Altimus X3B Evaluation Board Errata

Rev. F, 9/2005

This document describes the known errata and limitations of the Altimus PrPMC card for the Sandpoint reference platform. In all cases, if an errata has a workaround, it is applied to the system before shipped to customers.

Errata 14 Details

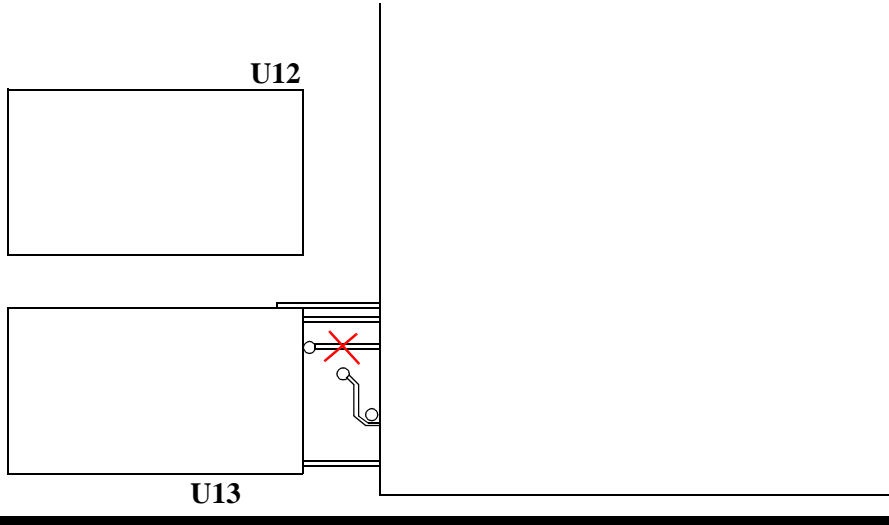
13	Design	Interrupts not receivable on IRQ0* (in spite of errata #12) when not in SYSCON* mode, which is true on SPX# systems with serial numbers ≥ 6000 , or when SYSCON is not selected.	Lack of interrupts on IRQ0*.	1. Add a wire or solder-bridge across U2 (QS3384) pins 12, 13 and 14. Note: For SPX3 systems ≤ 5999 : Select MPMC mode on the MPMC and SPX3 (SYSCON LED should be active). For X4: Connect INTA# to IRQ0# with no QS involvement (new standard method).	E
14	Device/Design	The MPC7410 will drive L2ADDR[17] (normally unused) high in 1MB private memory mode or with 2MB L2 configured as half cache, half private memory, it will drive L2ADDR[17] high for the private memory accesses. MPC755-equipped Altimus boards do not need this rework.	Private-memory modes do not work for some modes/sizes (cache works fine).	For MPC7410: 1. On the top of the board, between the processor and the SRAMs, cut the trace shown on the detail view. 2. Change R67 to 22 ohms. This disconnects CA17 from the processor, and R67 pulls CA17 low. For X4: Disconnect CA17.	F
